Rezoning Transportation Analysis

Petition Number: 2019-009

Revision Log:	Date	Description
	02-14-2019	First Review

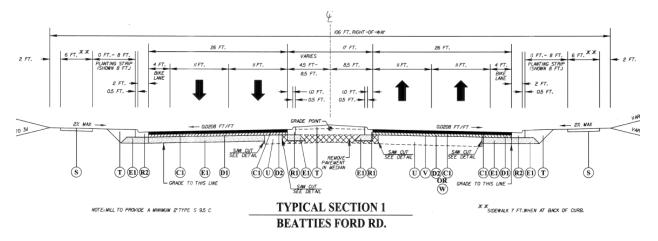
1. **Curbline:** The proposed zoning district has a setback measured from back of proposed future rightof-way line. The location of the future back of curb is as follows:

a. Beatties Ford Road - 33' as measured from the street's existing centerline.

- i. The petitioner shall revise the site plan and conditional note(s) to commit to construct the curb and gutter. The site plan should label and dimension the future curb and gutter from the centerline of the road. See note 3 for details.

- c. The petitioner shall commit to implement two (2) 150' southbound left turn storage lanes with appropriate bay tapers at the site's northern entrance on Bob Beatties Rd. and at Trinity Rd. The below Beatties Ford Rd. typical section has been modified to eliminate the 4-foot on-street bike lane and add a 12' multi-use path along the site's Beatties Ford frontage.
